SYSTEM BLOCK DIAGRAM

PROJECT : QU1

44. 12/21 P19---del R443,ADD R446(HW LOSE)
45. 12/26 P16---change Y2 P/N to meet ACL.(BG625000737)
46. 12/21 P17---ADD R122 for HW lose
47. 12/23 P19---Add R324 for LCD white screen issue
48. 12/27 P19---Change F8=7A fuse (P/N:DK700WFW006)(LCD INRUSH CURRENT=3A)
49. 12/23 P26---del R587(LAN link issue)
50. 12/29 P26---change CN11 (P/N:DFTJ12FS001)(Change LED color)
51. 12/26 P31---change CN5,CN8 P/N to meet ACL.(DFHD52MS057)
52. 12/29 P12---ADD R689 to link VCC3(Therm_Alert# must push Hi)

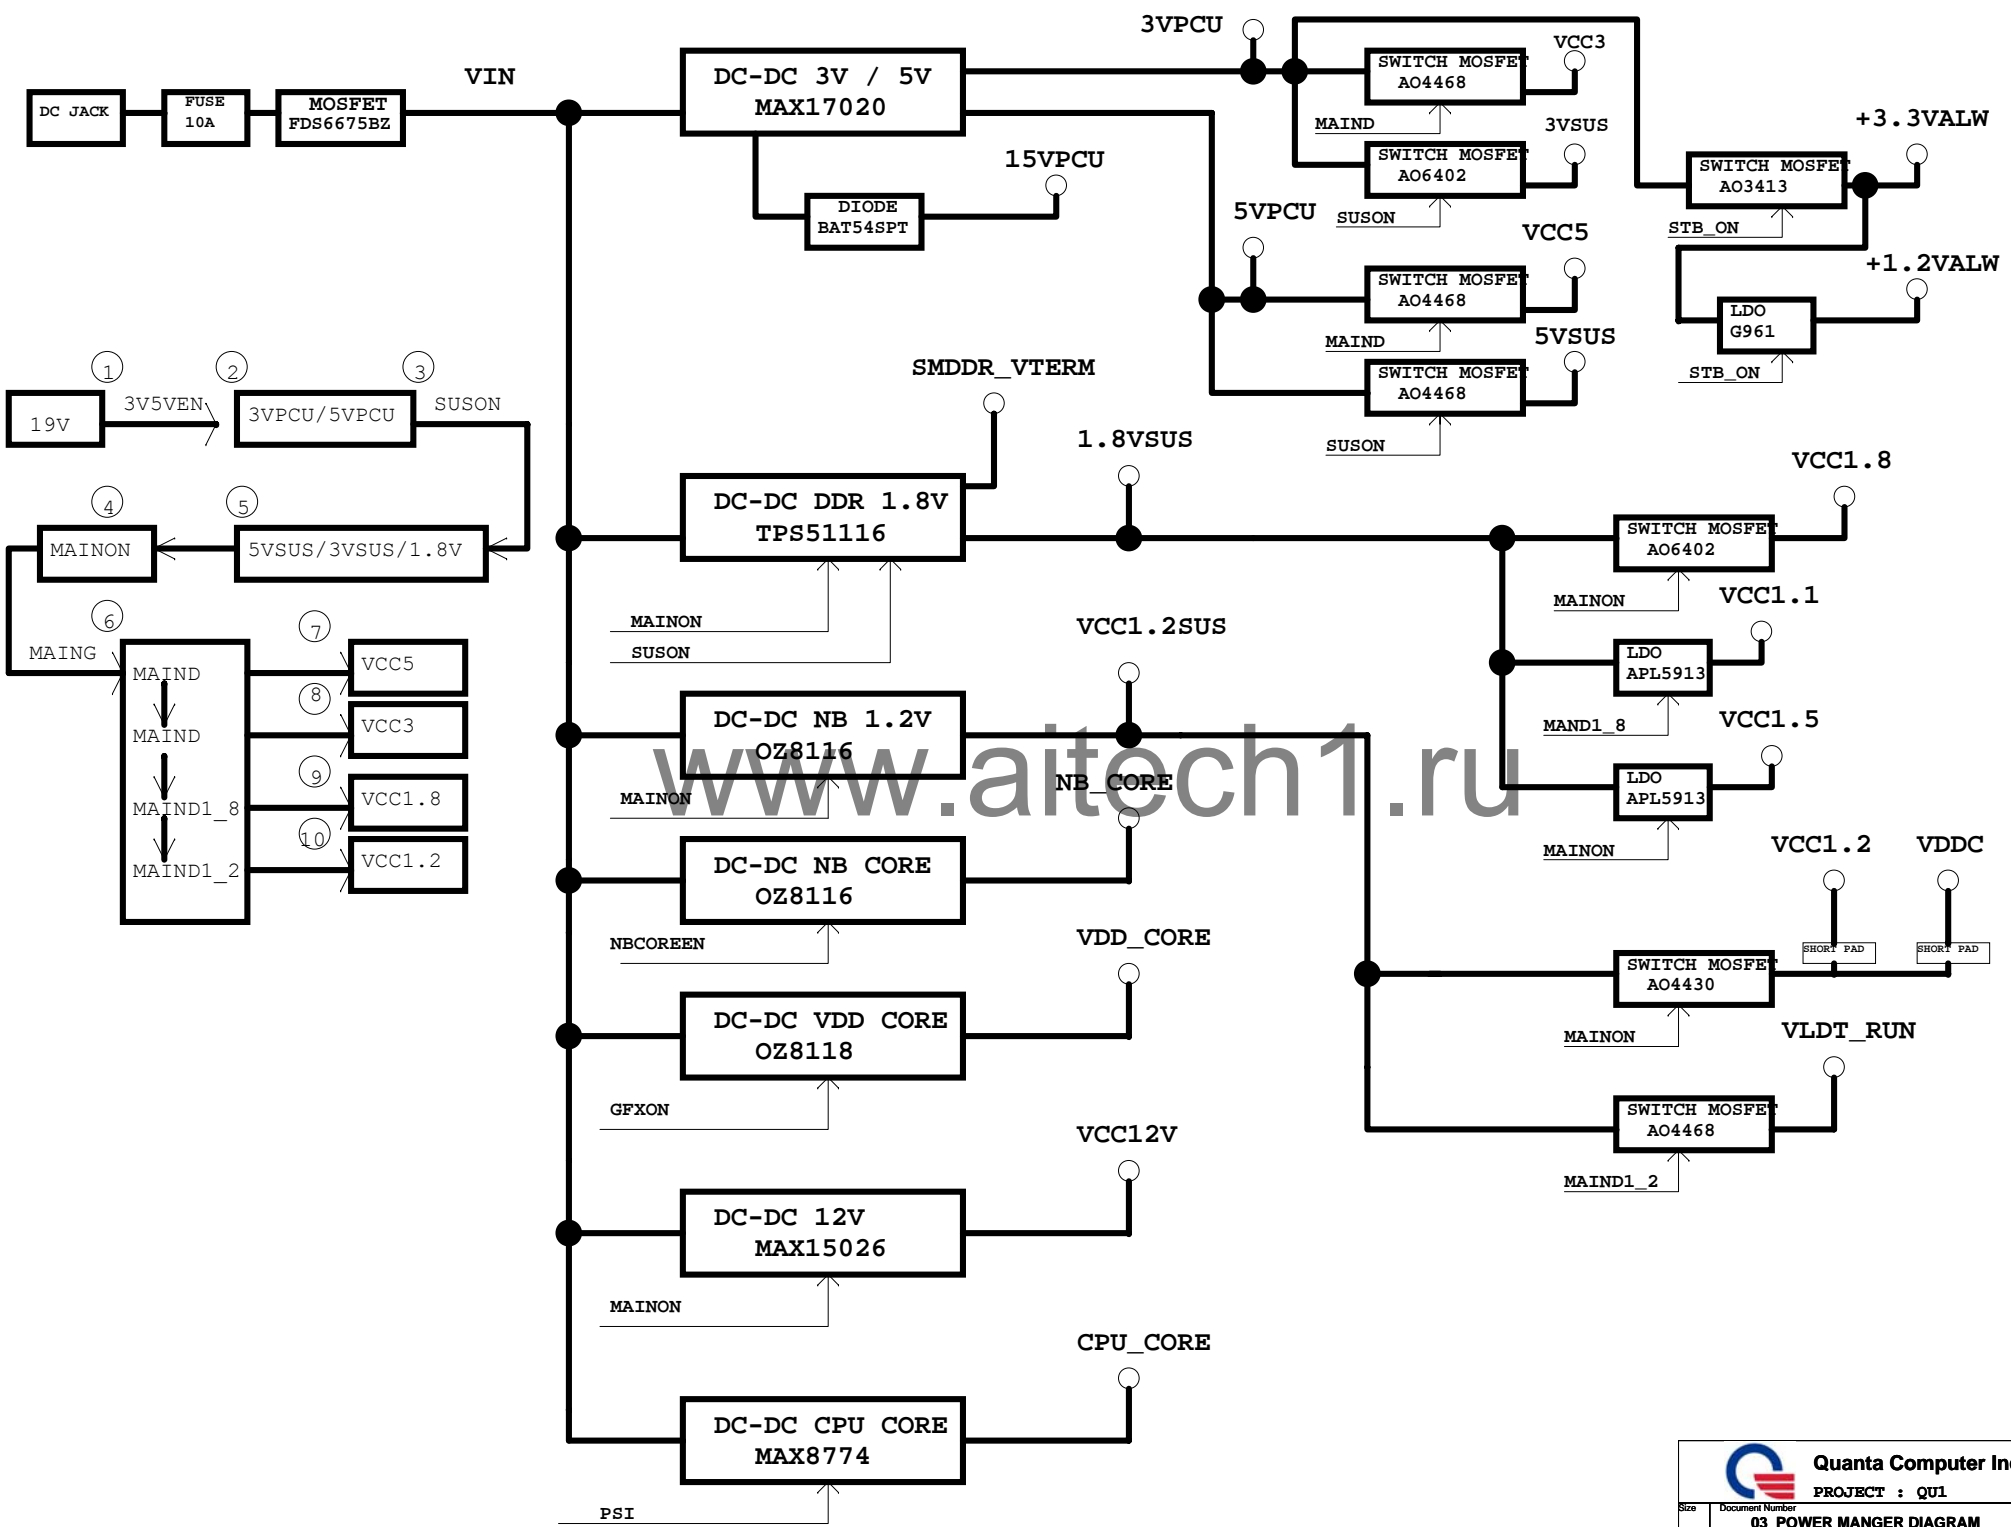
12/01 change the footprint to SOT23_213-3_3-2

12/02 change H2,H3,H6,H7 footprint to ????(waitting Layout team confirm)

12/02 change H5,H11,H12,H14,H15 footprint to ???(waitting Layout team confirm)
